CK-495

REQ. ITEM	PART NO.	DESCRIPTION	SYMBOL
THE TECHNICAL MATERIEL CORP. MAMARONECK, NEW YORK			
SCHEMATIC DIAGRAM PA SECTION			
ADDENDUM FIELD EQUIPMENT			
	UZZO	DRAWN	FINAL APPROVAL
		CHECKED	
FINISH & SPEC. NO.		ELEC. DES. APP.	MECH. DES. APP.
			CK-495

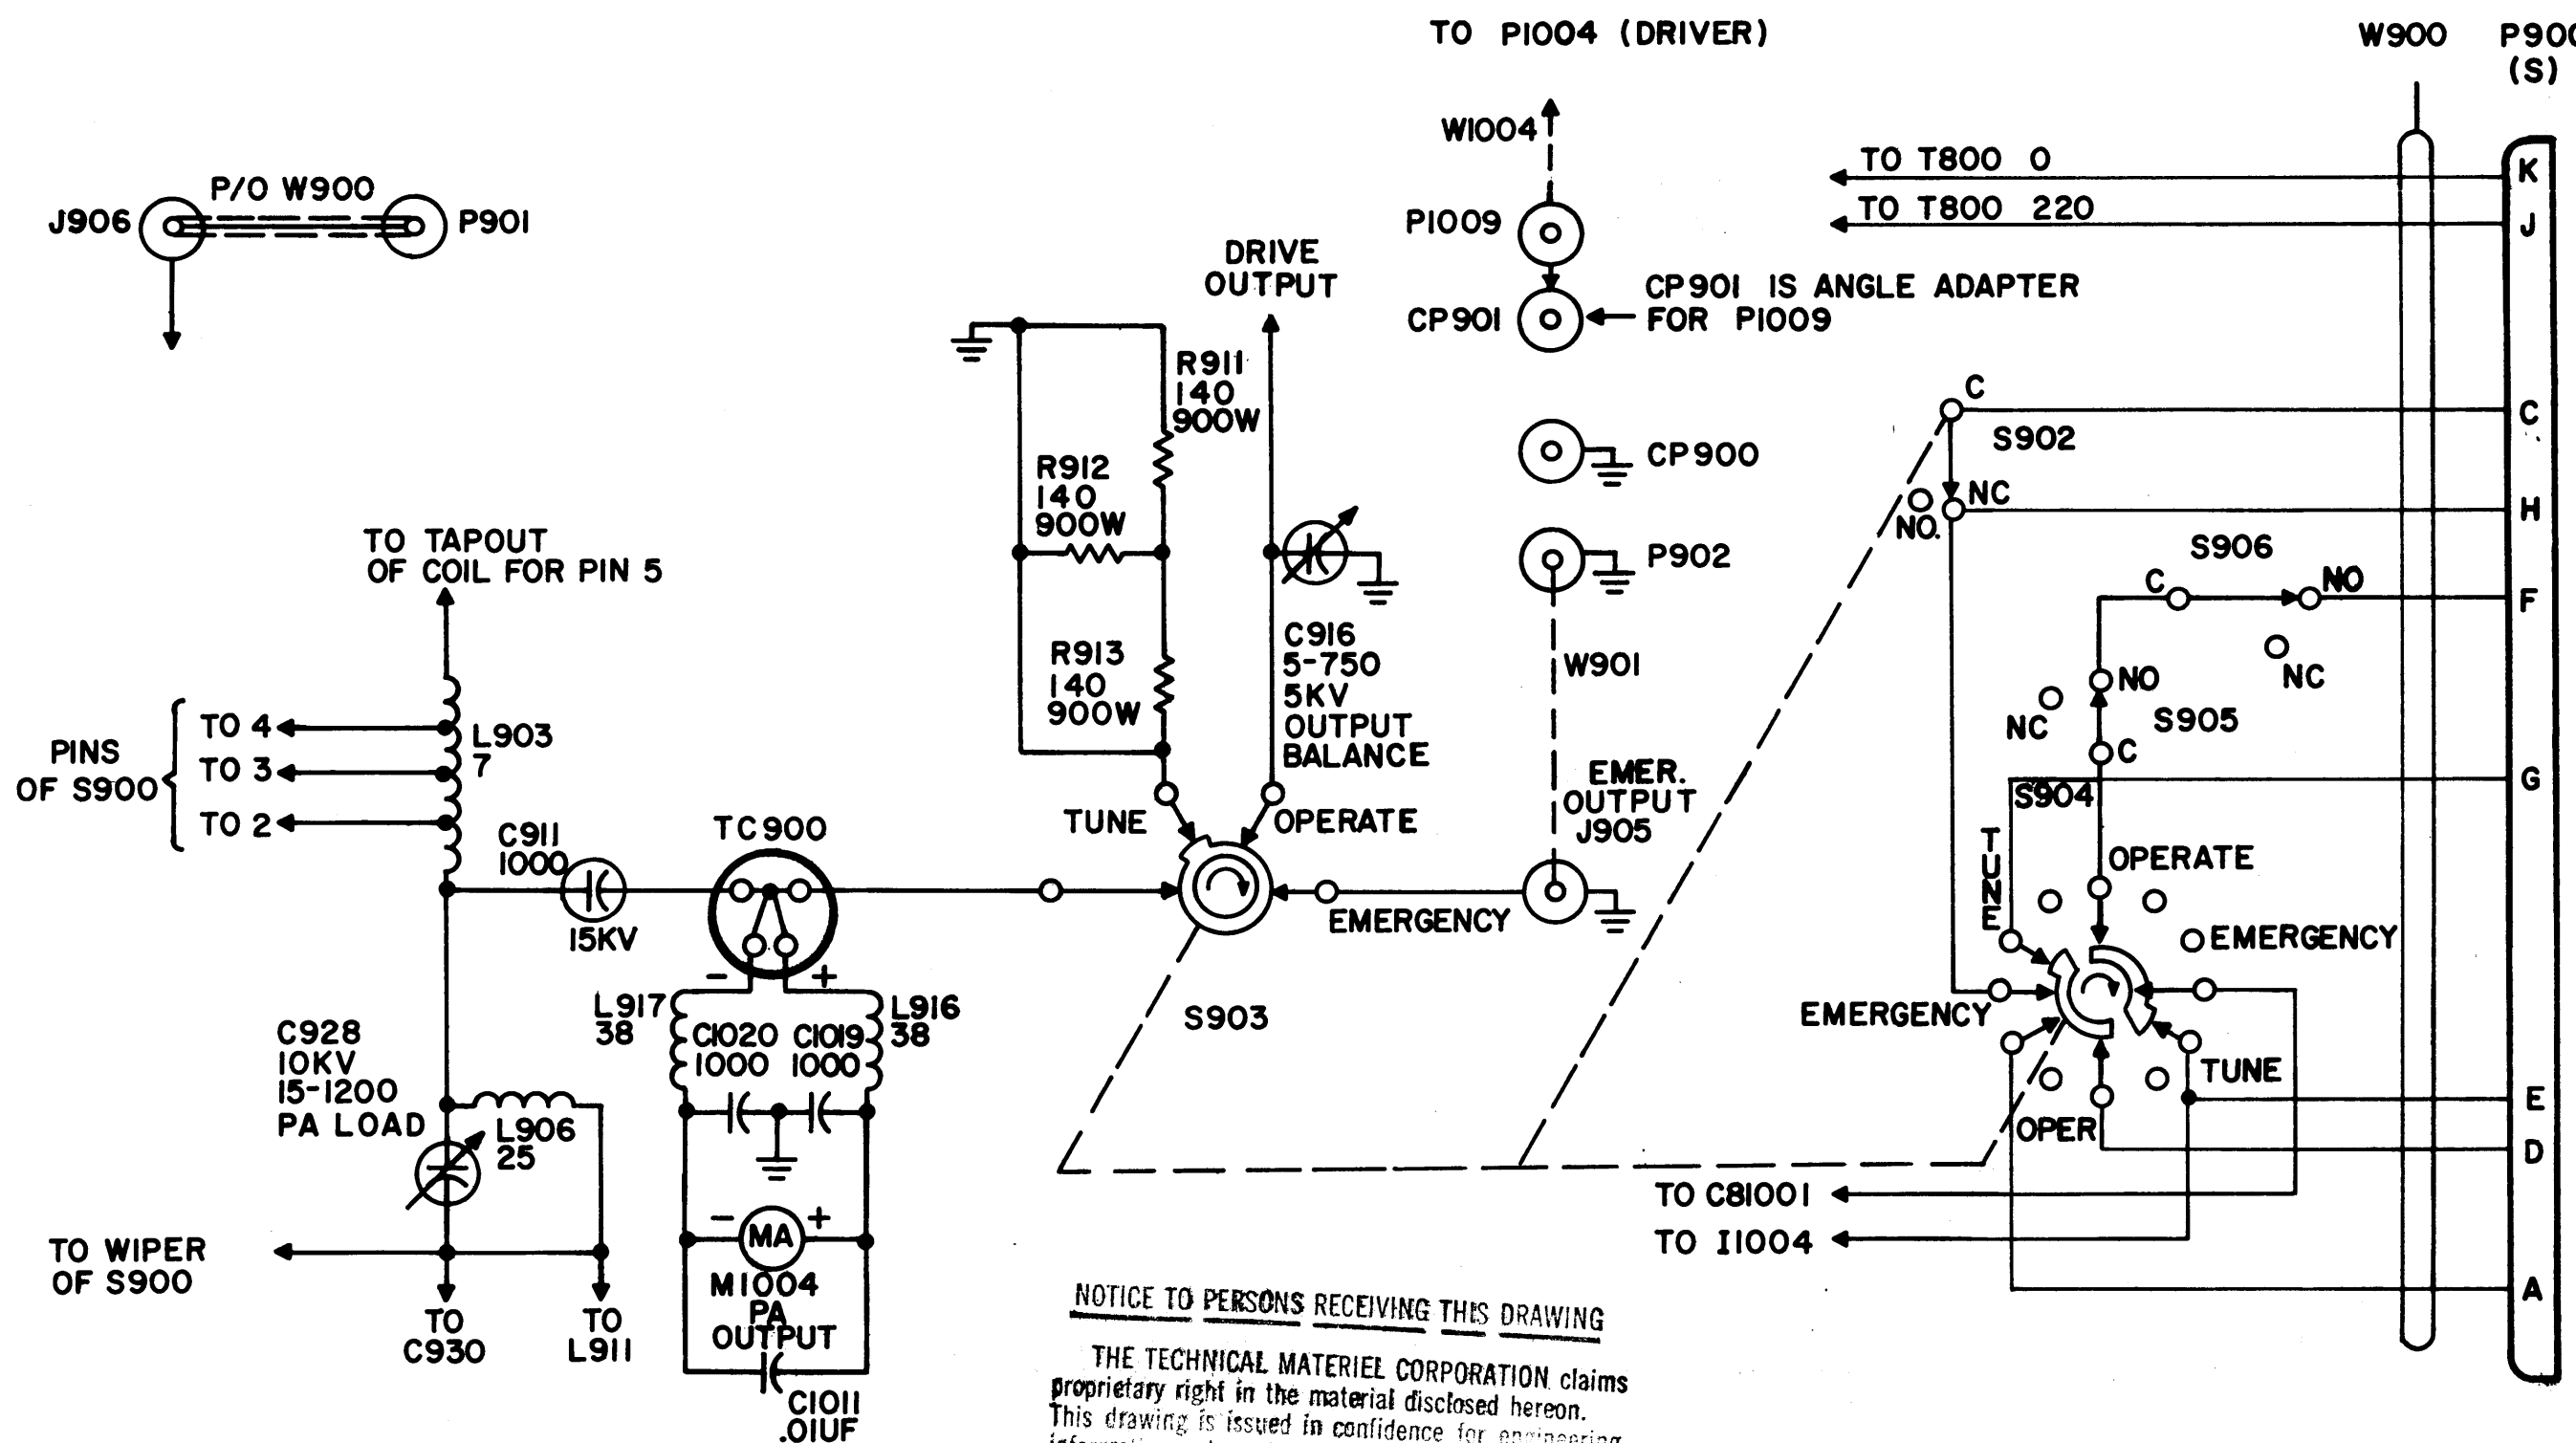
NOTE - FOR IKW EMER. OUTPUT DISCONNECT LEAD FROM S903 EMERGENCY POSITION TO J905 AND CONNECT CABLE W901 (LOOSE ITEM) AND W1004 AS SHOWN
